Sundry Print Report

Well Name: BLUE KRAIT 23 FED Well Location: T24S / R33E / SEC 23 / County or Parish/State: LEA /

Sundry ID: 2689826

Type of Action: Variance

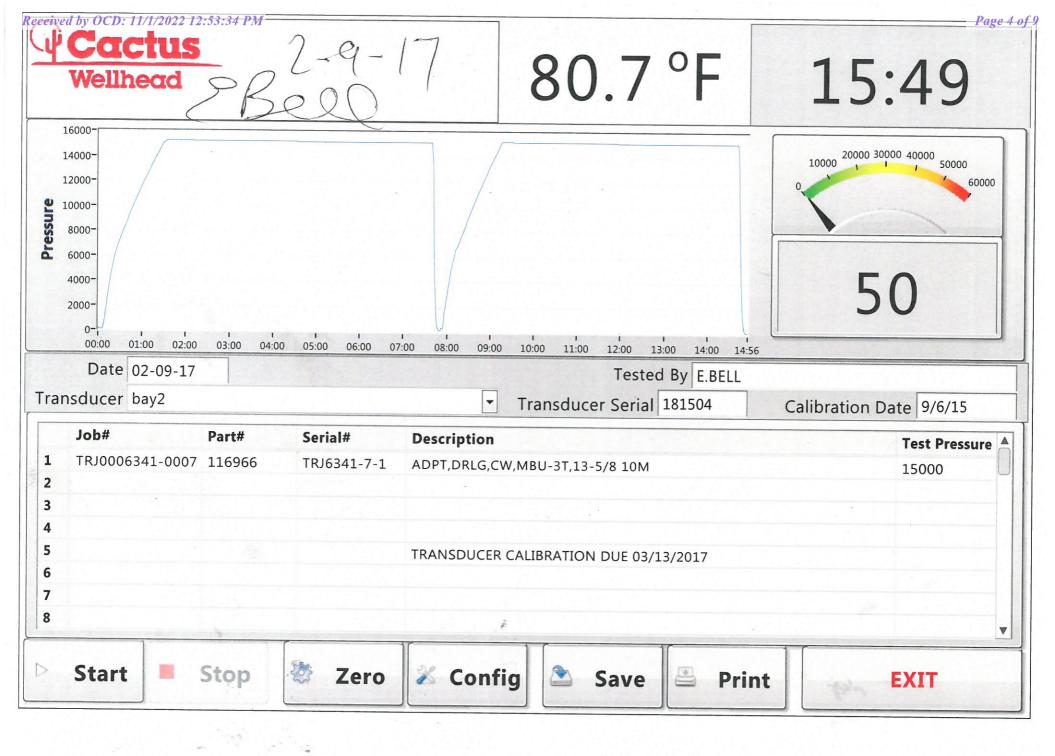
Devon Energy requests to only test BOP connection breaks after drilling out of surface casing and while skidding between wells which conforms to API Standard 53 and industry standards. This test will include the Top Pipe Rams, HCR, Kill Line Check Valve, QDC (quick disconnect to wellhead) and Shell of the 10M BOPE to 5M for 10 minutes. If a break to the flex hose that runs to the choke manifold is required due to repositioning from a skid, the HCR will remain open during the shell test to include that additional break. The variance only pertains to intermediate hole-sections and no deeper than the Bone Springs Formation where 5M BOP tests are required. The initial BOP test will follow OOGO2.III.A.2.i, and subsequent tests following a skid will only test connections that are broken. The annular preventer will be tested to 100% working pressure. This variance will meet or exceed OOGO2.III.A.2.i per the following: Devon Energy will perform a full BOP test per OOGO2.III.A.2.i before drilling out of the intermediate casing string(s) and starting the production hole, before starting any hole section that requires a 10M test, before the expiration of the allotted 14-days for 5M intermediate batch drilling or when the drilling rig is fully mobilized to a new well pad, whichever is sooner. We will utilize a 200' TVD tolerance between intermediate shoes as the cutoff for a full BOP test. The BLM will be contacted 4hrs prior to a BOPE test. The BLM will be notified if and when a well control event is encountered. Break test will be a 14 day interval and not a 30 day full BOPE test interval. If in the event break testing is not utilized, then a full BOPE test would be conducted.

- 1. Well Control Response:
- 1. Primary barrier remains fluid
- 2. In the event of an influx due to being underbalanced and after a realized gain or flow, the order of closing BOPE is as follows:
 - a) Annular first
 - b) If annular were to not hold, Upper pipe rams second (which were tested on the skid BOP test)
 - c) If the Upper Pipe Rams were to not hold, Lower Pipe Rams would be third

All Previous COAs Still Apply. Variance request procedure is approved as written, please see below general conditions for variance.

- BOPE Break Testing is ONLY permitted for 5M BOPE or less.
- BOPE Break Testing is NOT permitted to drilling the production hole section.
- While in transfer between wells, the BOPE shall be secured by the hydraulic carrier or cradle.

- Any well control event while drilling require notification to the BLM Petroleum Engineer (575-706-2779) prior to the commencement of any BOPE Break Testing operations.

- A full BOPE test is required prior to drilling the first deep intermediate hole section. If any subsequent hole interval is deeper than the first, a full BOPE test will be required (200' TVD tolerance between intermediate shoes is allowable).

- The BLM is to be contacted (575-361-2822 Eddy County) or (575-393-3612 Lea County) 4 hours prior to BOPE tests.
- As a minimum, a full BOPE test shall be performed at 14-day intervals.

- In the event any repairs or replacement of the BOPE is required, the BOPE shall test as per Onshore Oil and Gas Order No. 2.
